**METROPOLITAN GOVERNMENT OF NASHVILLE AND DAVIDSON COUNTY**

**STAFF RECOMMENDATION**  
**1701 A and C Blair Boulevard and 2117 and 2121 Belmont Boulevard**  
**September 16, 2015**

**Application:** New construction-infill  
**District:** Belmont-Hillsboro Neighborhood Conservation Zoning Overlay  
**Council District:** 18  
**Map and Parcel Number:** 10416040600, 10416040500, 10416040400, 10416040300  
**Applicant:** Allard Ward Architects  
**Project Lead:** Melissa Baldock, melissa.baldock@yahoo.com

Figure 1: Corner of Belmont and Blair Boulevard

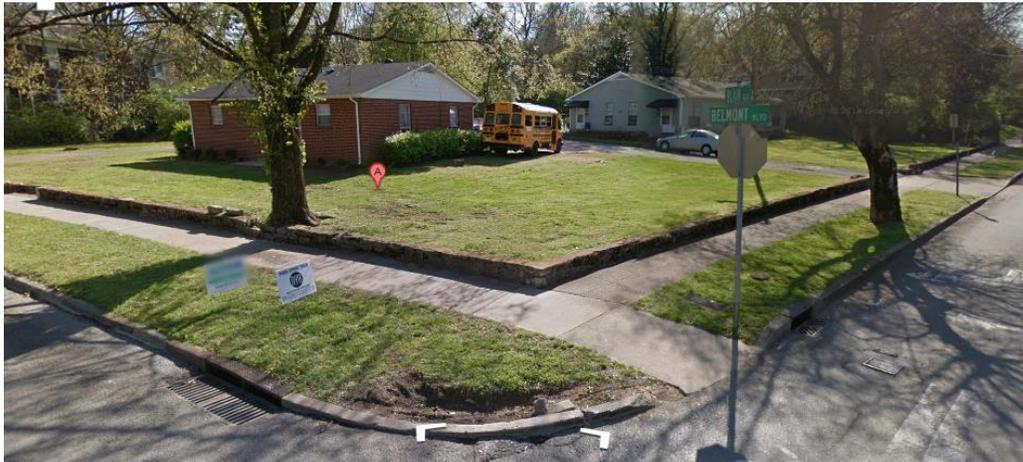
**Analysis and Findings:** The project is for a multi-family development on what are currently four lots at the corner of Blair and Belmont Boulevards. In March, the Commission determined that the massing, height, scale, setback, rhythm of spacing, roof form, orientation, and parking plan of the front units and the site plan met the design guidelines.

**Rear Units Massing:** The five units at the rear of the lot will not have any street frontage, but will be connected to Blair Boulevard via a walkway. The units will be approximately twenty-five feet (25') from the alley, and ten feet (10') from the side property line. The rear units will be two stories and will have an average height of approximately thirty feet (30') from grade. These units will be subordinate to the front-facing units by being one story and approximately six feet (6') shorter. Staff finds this to be appropriate. Like the front units, the structure's primary roof form is flat, although the units will incorporate 12/12 gable forms. The parking for the units will be uncovered surface parking, at the rear, just off the alley, which is appropriate. Staff finds that the massing, height, scale, setback, rhythm of spacing, roof form, orientation, and parking plan to meet Section II.B. of the design guidelines.
